PIC12CE67X Rev. B Silicon/Data Sheet Errata

The PIC12CE67X (Rev. B) parts you have received conform functionally to the Device Data Sheet (**DS30561** and **DS40181A**), except for the anomalies described below.

In the Device Data Sheet (DS30561B), the following clarifications and corrections should be noted.

FIGURE 5-1: GP0 and GP1 Block Diagram

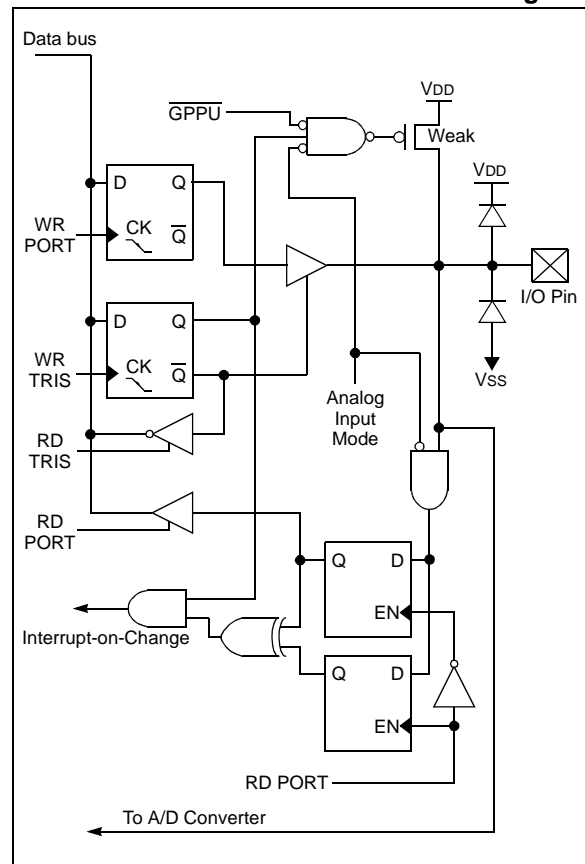
3. Module: GPIO Register

Clarification to the "GPIO", Section 5.1 is provided. New I/O drawings were added.

GPIO is an 8-bit I/O register. Only the low order 6 bits are used (GP<5:0>). Bits 6 and 7 (SDA and SCL, respectively) are used by the EEPROM peripheral on the PIC12CE673/674. Refer to Section 6.0 and Appendix B for use of SDA and SCL. Please note that GP3 is an input only pin. The configuration word can set several I/O's to alternate functions. When acting as alternate functions, the pins will read as '0' during port read.

Pins GP0, GP1 and GP3 can be configured with weak pull-ups and also with interrupt-on-change. The interrupt on change and weak pull-up functions are not pin selectable. If pin 4, (GP3), is configured as \overline{MCLR} , a weak pull-up is always on. Interrupt-on-change for this pin is not set and GP3 will read as '0'. Interrupt-on-change is enabled by setting bit GPIE, INTCON<3>.
